REPRESENTATION FROM M & T FLORUSSE 54 and 56
CHANNEL HIGHWAY KINGSTON

Changes to F3.0
Former Kingston High School Site Specific Area
Plan PSA-2019-3
Version 2 – Amended and Re Advertised
10-9-2020

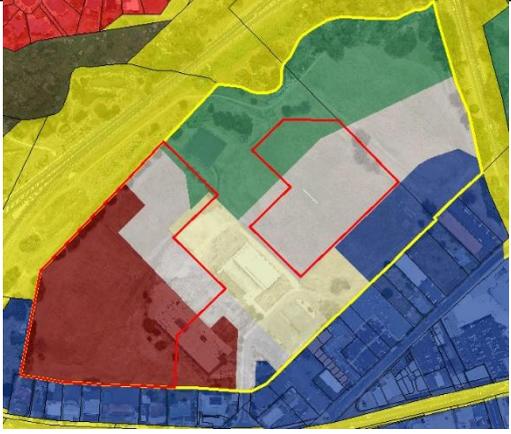
Our representation is directed to the Rezoning of the area of land in Kingston Park as detailed in point 2, which backs onto 44 – 58 Channel Highway and with the objective detailed in point 7.

While the amendment has been deemed “substantially altered”, the matters of our concern have not been addressed. In addition, F3.7.3.1 A4 now allows for and increased building height in the proposed Inner Residential zone from 8.5m to 10m. There is no evidence that the increase in building height will not adversely affect lower level solar access to any proposed development on our adjoining properties to the south.

The properties bounding Channel Highway which are zoned Central Business are aging and will be in the foreseeable future redeveloped in accordance with the business use intended. The change of zoning of adjoining land in Kingston Park from Urban Mixed Use to Inner Residential will place significant restraints on Building Heights and Setbacks and Fenestration of any commercial development as follows:

- (i) The setback requirement will create a minimum 6.0 up to 10m metre dead area at the rear/northern side of any future development along Channel Highway, in conflict with 22.4.4 A1(d) or 16.4.2 A2 to avoid creating entrapment spaces.**

- (ii) Building Height will be limited to 8.5 metres or less within 10 metres of the rear boundary, as deemed appropriate for the proposed residential development to the north. This will also create design and utilization difficulties when combined with a 6 to 10m metre rear setback and still not guarantee privacy to the north. This may result in the loss of 651m² of potential developed floor area (at a building height of 20m) for each title abounding the proposed “Inner Residential Zone” Even at a modest annual rental of \$150 /m² the equates to a loss of annual income of \$976,50 per property.**

- (iii) Overshadowing of any Residential development will not be applicable as the Central Business zone is to the south. However, the consideration for “Residential Privacy” with regard to any north facing windows on any proposed commercial development would be seen to preclude any solar gain and fenestration.**

- (iv) There has been no proof presented that the increase in building height to 9.5m on the proposed “Inner Residential Zone” to the north will not cause increased shading to the adjoining properties to the south. We request shadow diagrams as of 21st June to demonstrate nil to acceptable affect on the adjoining properties.**

- (v) There will also be a conflict between the requirements for Commercial Passive Surveillance (22.4.4) with the Inner Residential objective for Privacy.**

- (vi) The newly imposed requirements for rear setbacks, building height and privacy will substantially reduce the utilization, energy efficiency, security and viability of any proposed commercial development in this section of Channel Highway.**

- (vii) In summary the change of zoning in Kingston Park applicable to the land adjoining Channel Highway would be seen as detrimental to the creation of a revitalized central business district in accordance with the objective of the Central Business Zone and point 7 of the proposed changes to Specific Area Plan for the Former Kingston Highschool Site (PSA 2019-3). It is nonsensical to fetter development on the less available “Central Business” zoned land with restrictions empowered by the more abundant “Inner Residential” zoned land.**
